Check Sheet

Company Name: Champion Int'l Corp  
Permit Number: AC 17-1420004  
PSD Number:  
County: Escombia  
Permit Engineer:  
Others involved:

1. 30"x42" BLUEPRINT:  
ENGINEERING FLOW  
DIAGRAM INC. G SYSTEM  
BLOW HEAT RECOVERY  
MODIF. PENSACOLA MILL
2. 30"x42" BLUEPRINT:  
NCG COLLECTION AND  
INCINERATION PROCESS  
AND INSTRUMENTATION  
DIAGRAM

RE: DER File No. AC17-142004

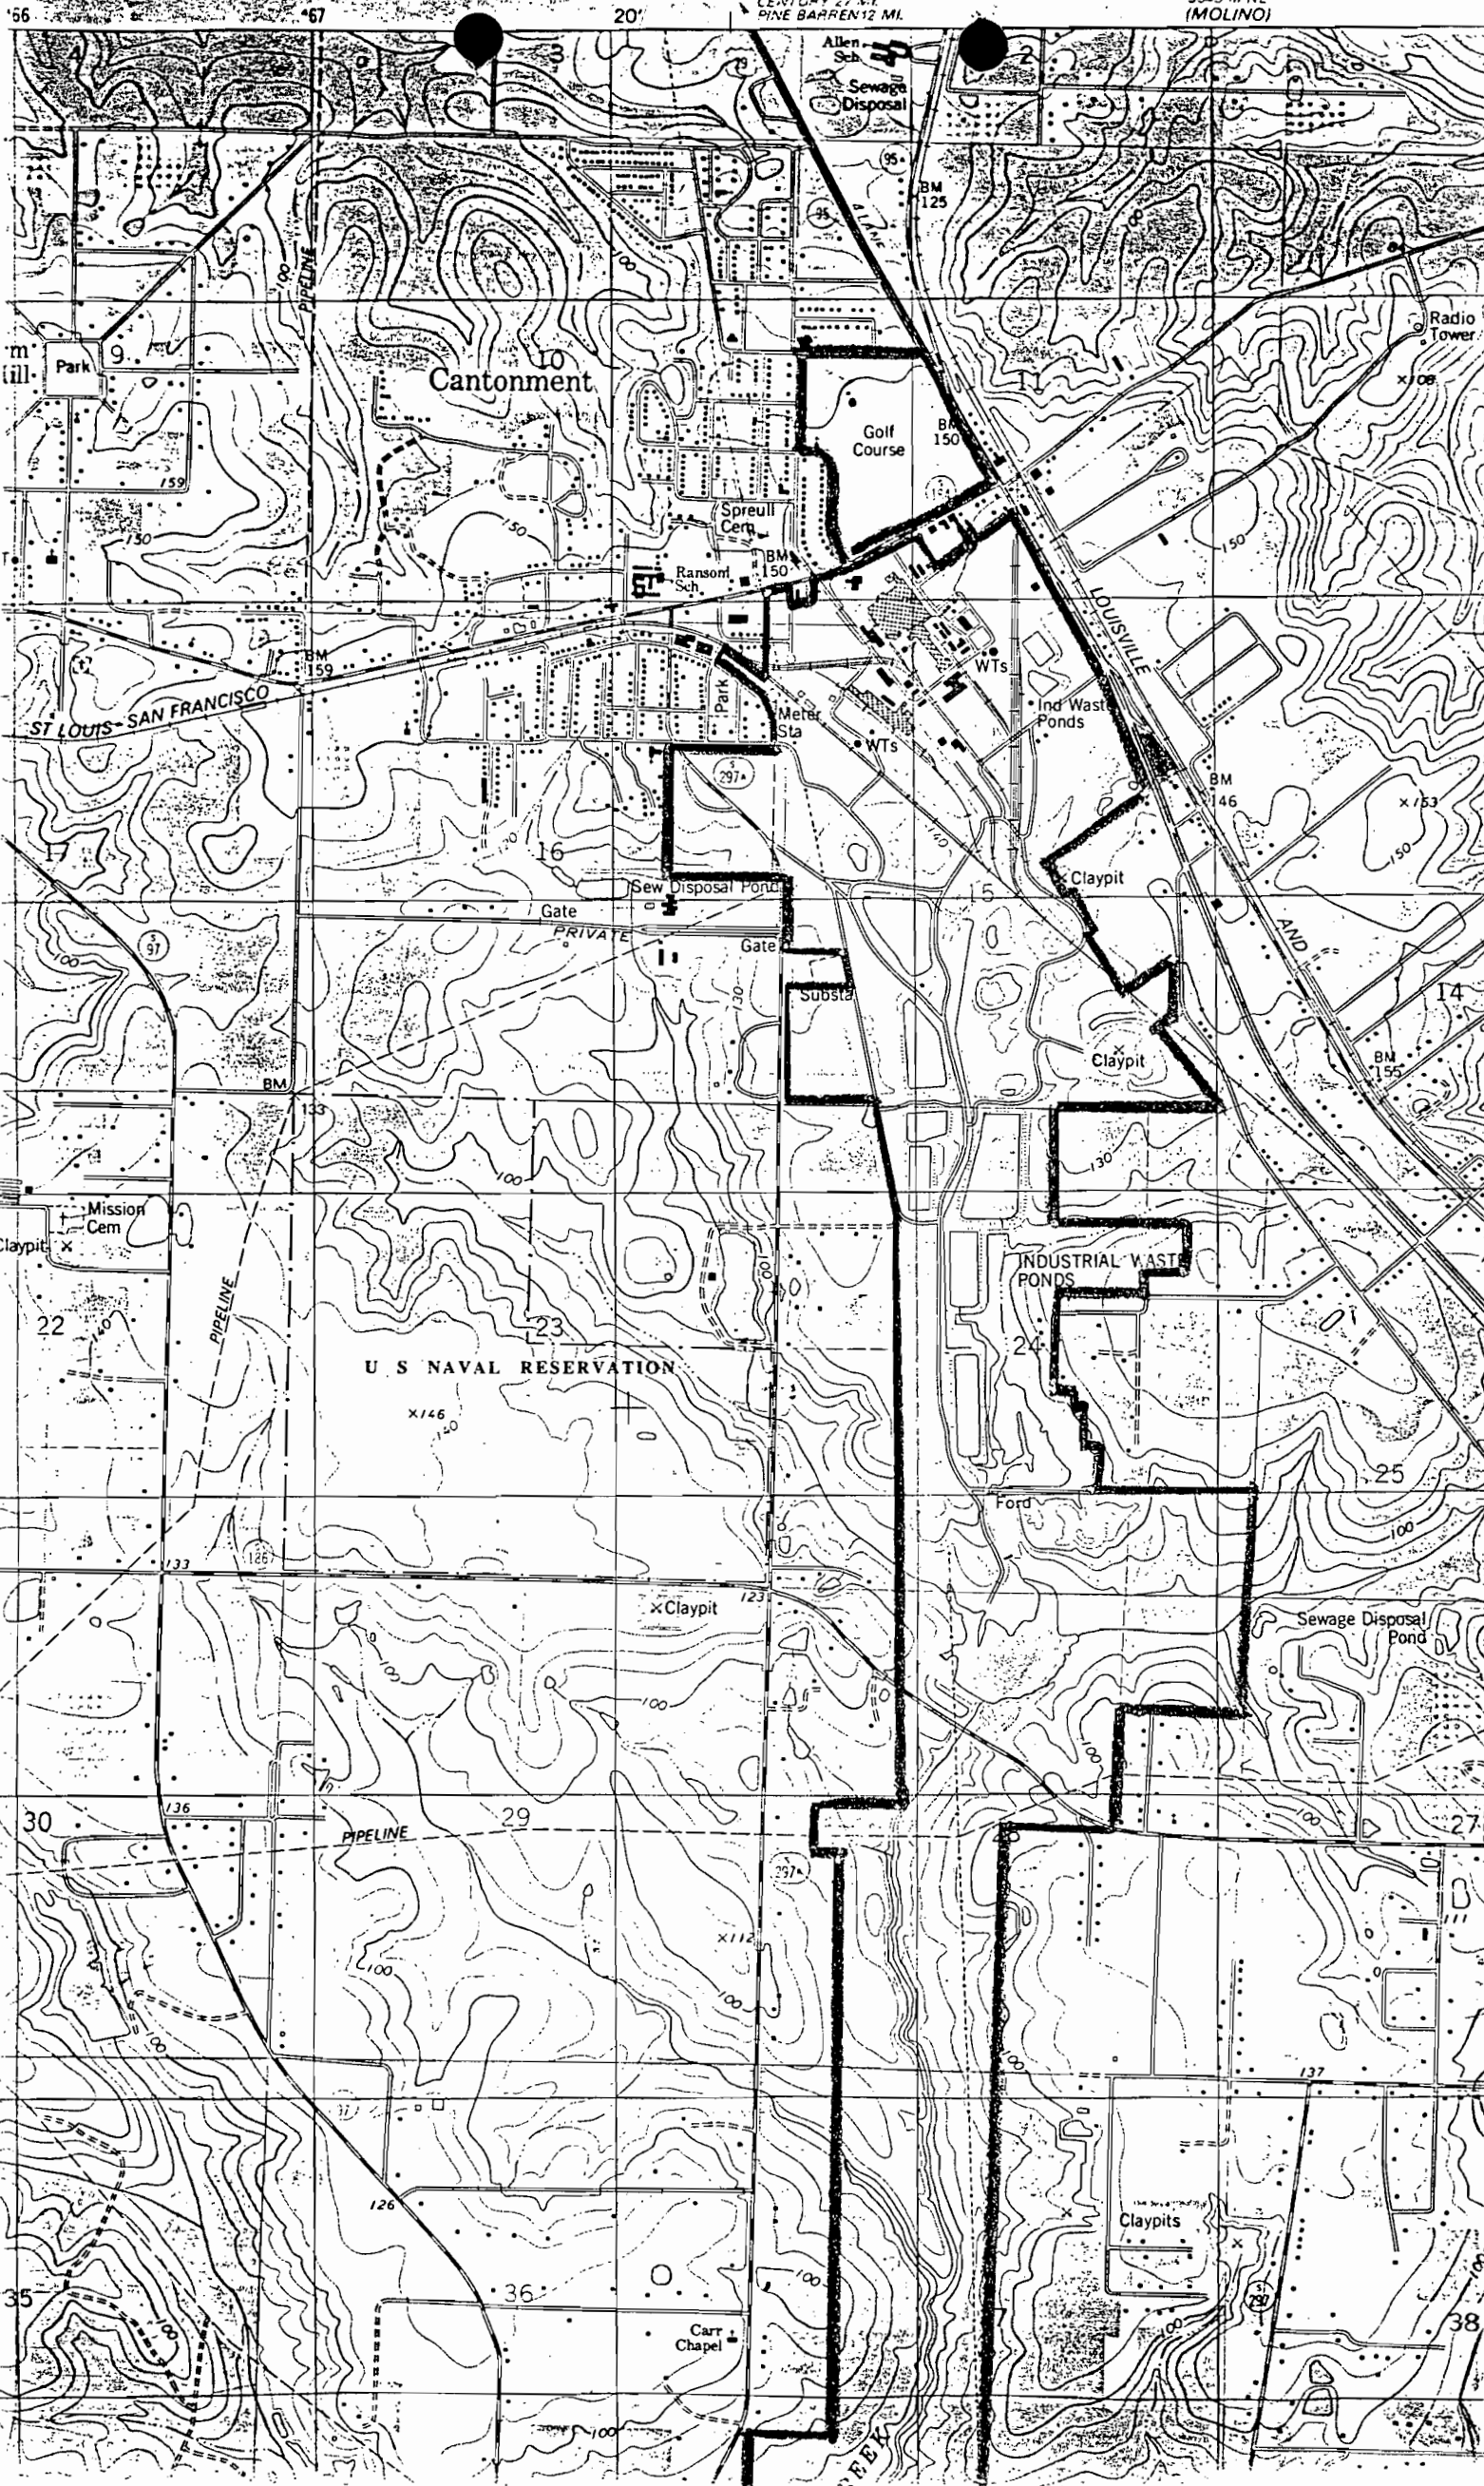
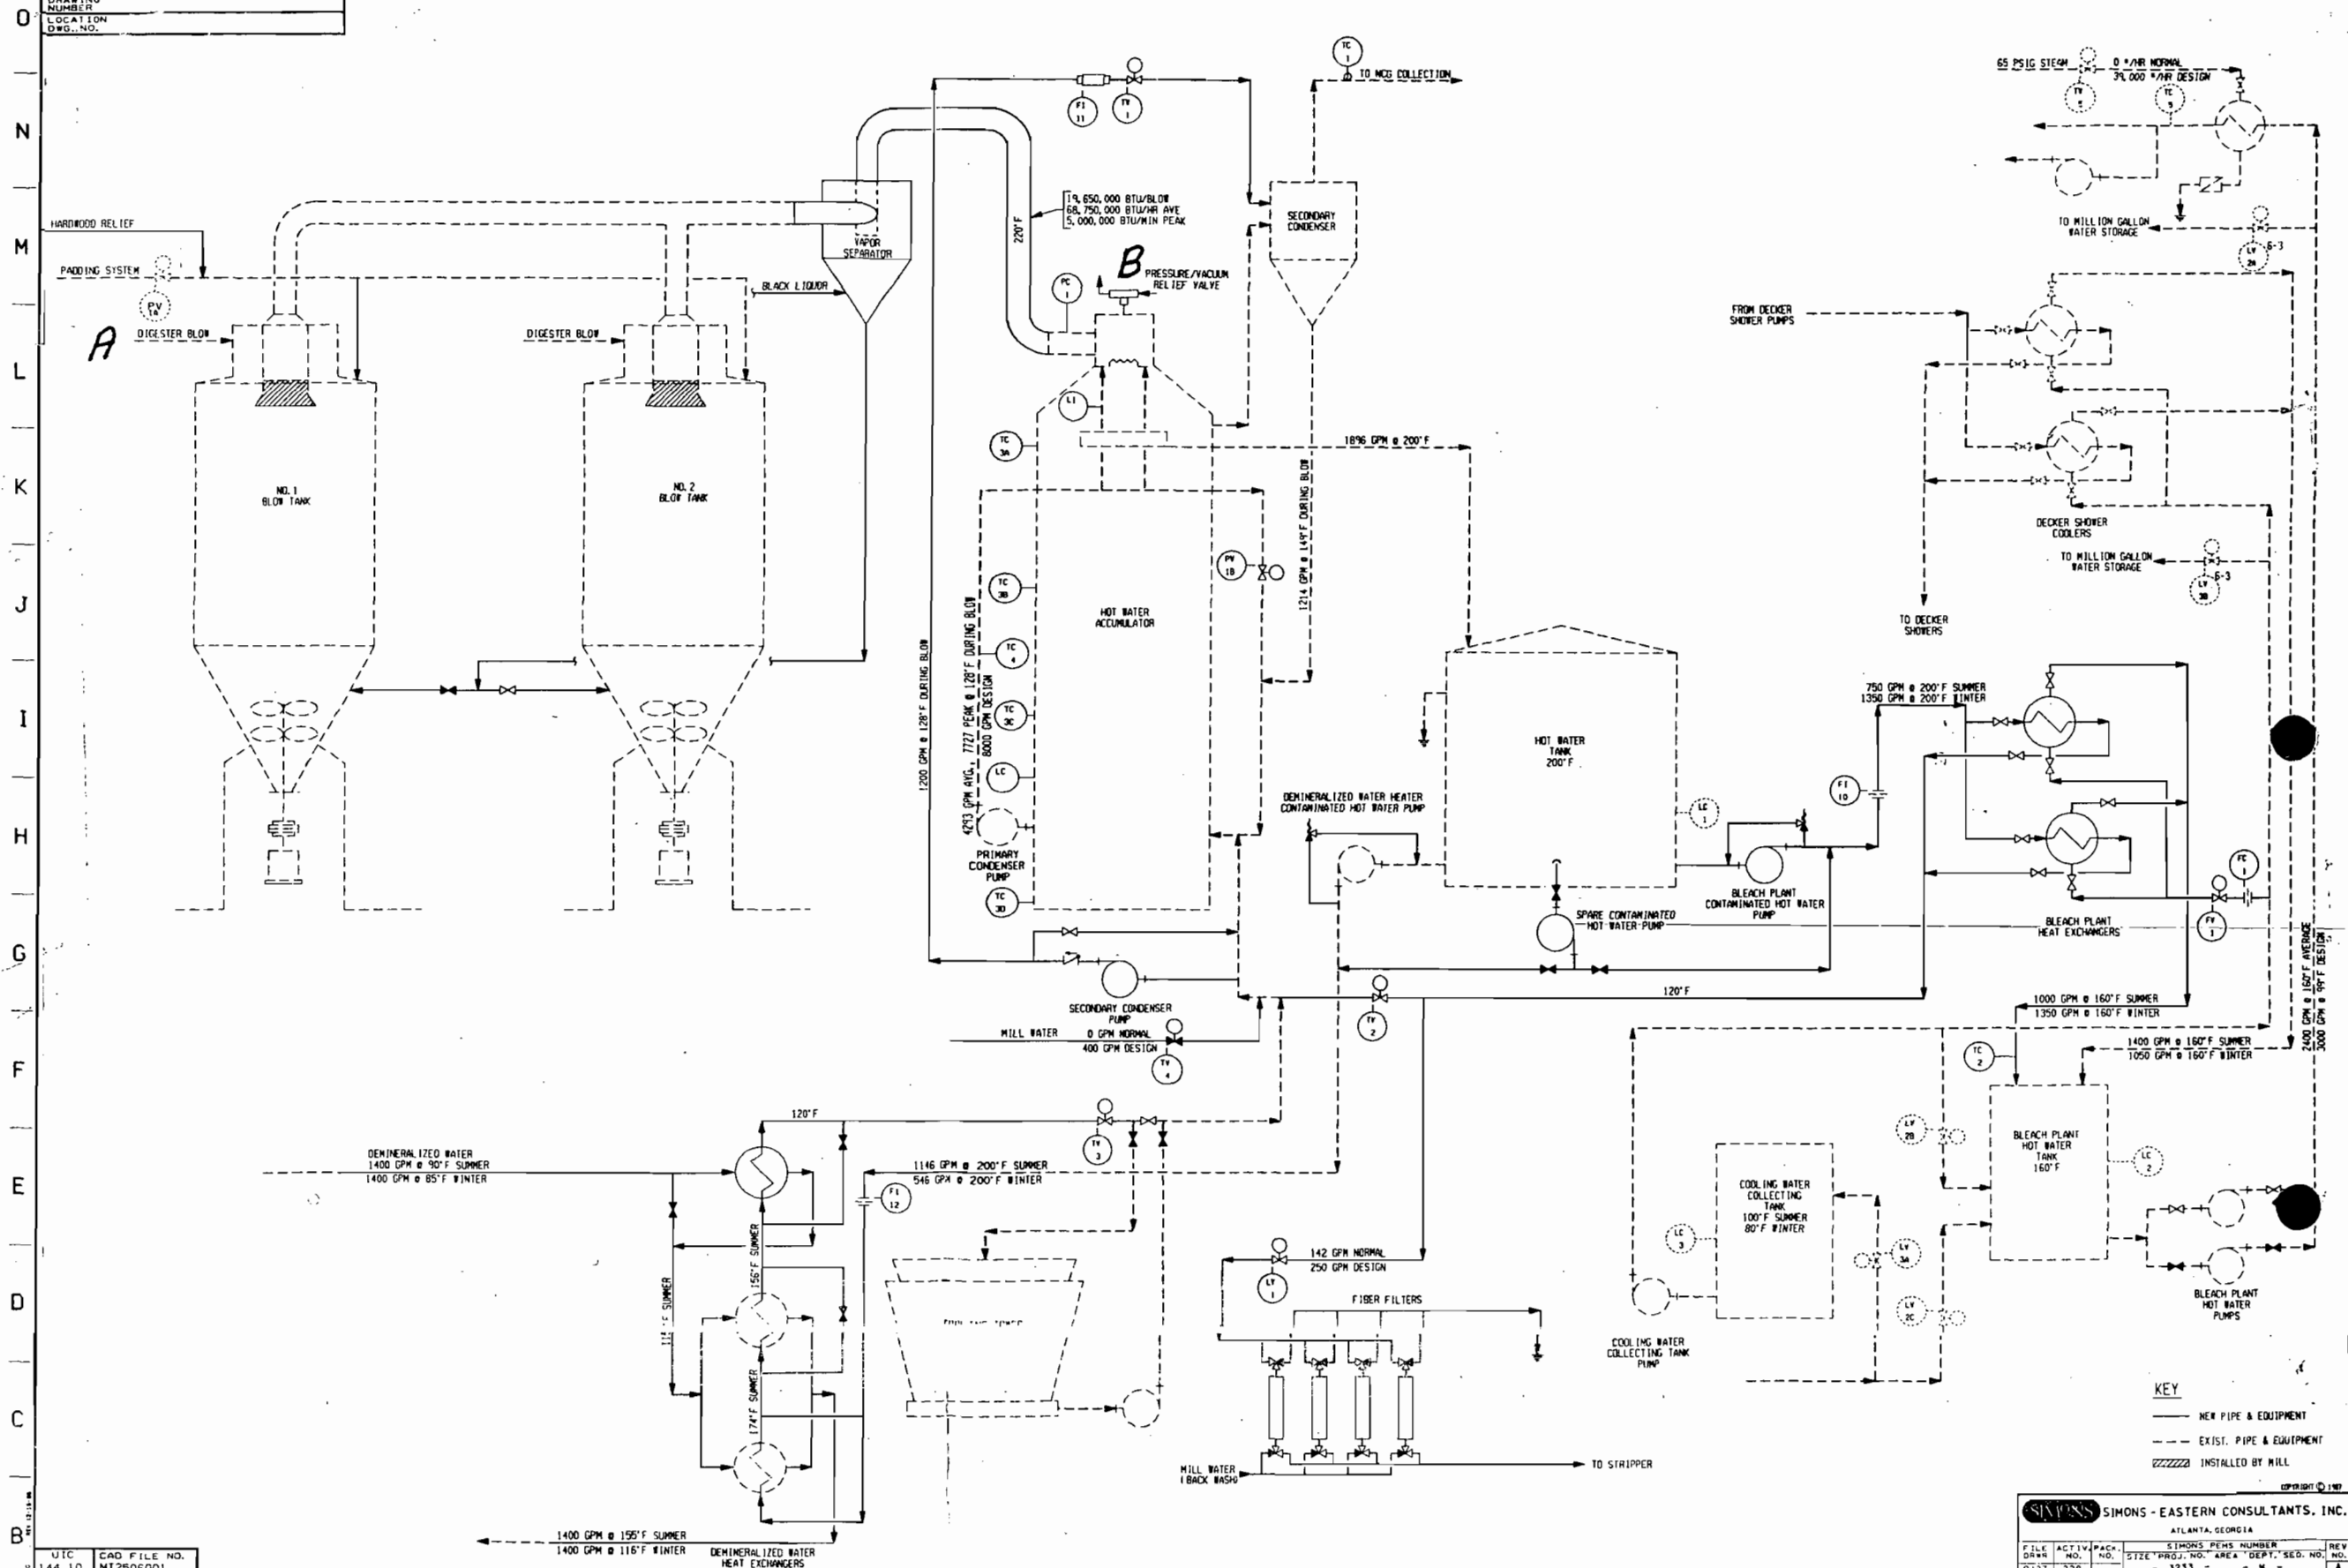
$$SO_2 = 70 \times \left( \frac{64}{34} \right) = 131.8$$

EFF. REQ'D TO ACHIEVE 40 TPY

$$\eta = \left( 1 - \frac{40}{131.8} \right) \times 100 = 69.7\%$$

DRAWING NUMBER: 10-001  
 LOCATION: D.W.G. NO.

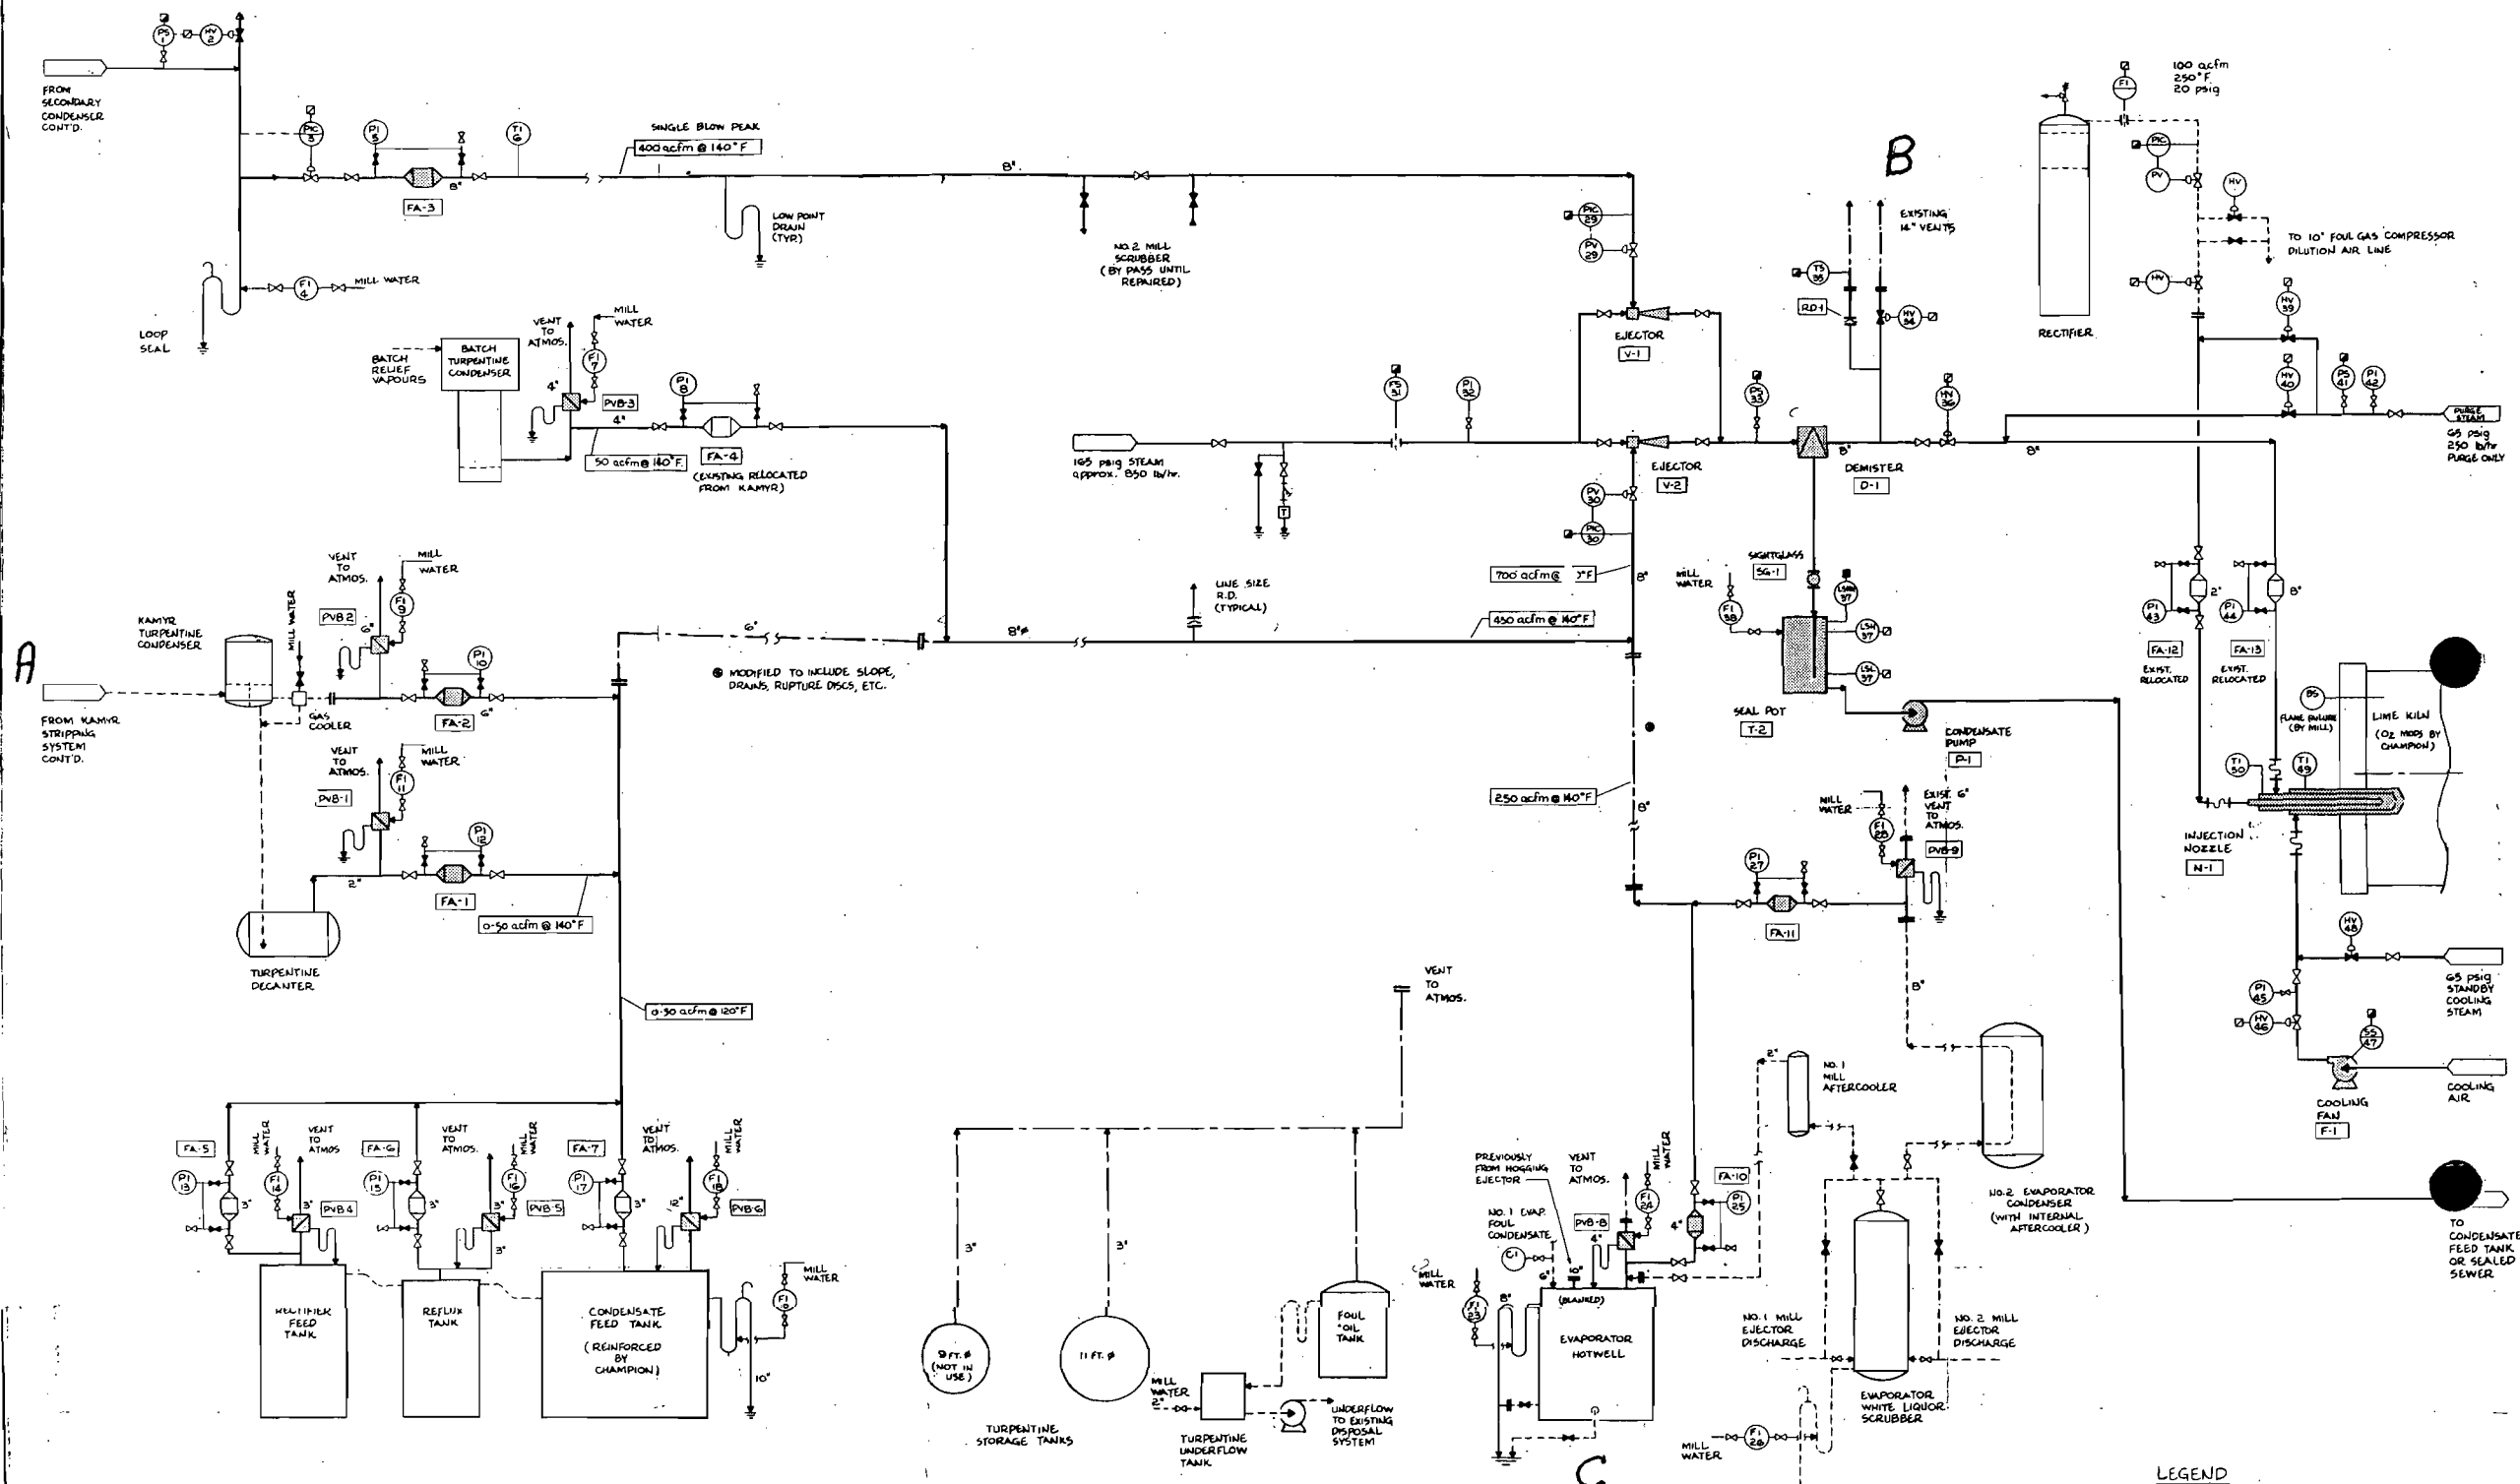
MODIFIED TO INCLUDE SLOPE, DRAINS, RUPTURE DISCS, ETC.

NOTE: TURPENTINE STORAGE TANKS AND FOUL OIL TANK NOT TO BE COLLECTED IN MODO-CHEMICS NCG SYSTEM (SEE STUDY)
